**TOP VIEW OF WING ARMORING WITH WING EXTENSION**

09-14 LATEST REVISION DATE  <i>Thomas E. McQuill</i> APPROVED BY BRIDGE ENGINEER		
	STANDARD DESIGN - 24' ROADWAY, THREE SPAN BRIDGE <b>PRETENSIONED PRESTRESSED CONCRETE BEAM BRIDGES</b> DECEMBER, 2006	
	<b>WING ARMORING DETAILS</b> C BEAMS	<b>H24-80-06</b>

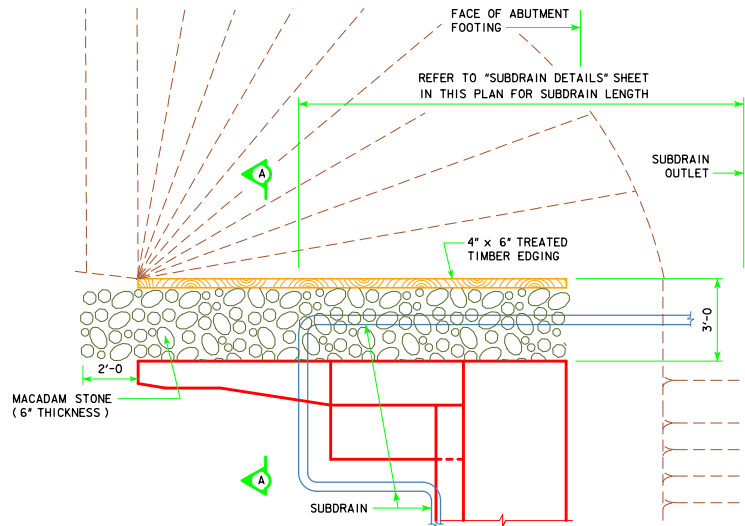
REVISED 09-14 - CHANGED THE AREA OF THE MACADAM STONE AREA TO 2'-0" IN FRONT OF THE BRIDGE WING.
